Date: May 26, 2026
Project: Jesse Cooper Building Improvements
MJ1002000063

Addendum No. 2

PROJECT: STATE OF DELAWARE
 OMB/ DIVISION OF FACILITIES MANAGEMENT
 OMB/ DFM CONTRACT #MJ1002000063
 JESSE COOPER BUILDING IMPROVEMENTS

SITE AERIAL

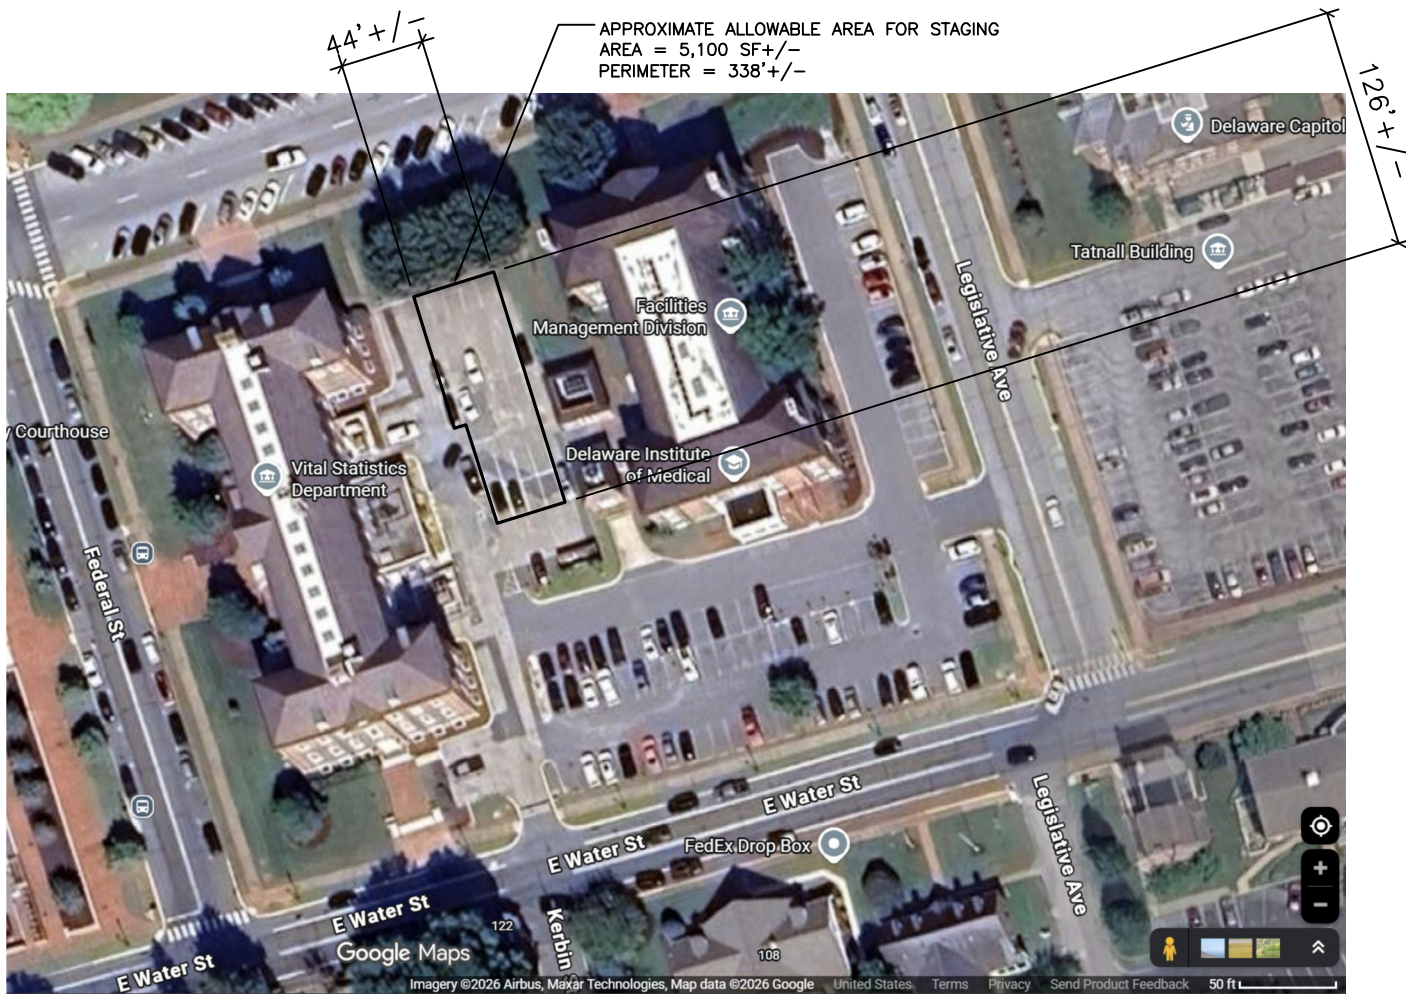
90. Can a google map be included to show the extents of what is going to be allowed for the lay down / storage / parking areas so we know the extents of temporary fencing? **See attached Drawing G9.1.**

APPROXIMATE ALLOWABLE AREA FOR STAGING
 AREA = 5,100 SF +/-
 PERIMETER = 338' +/-
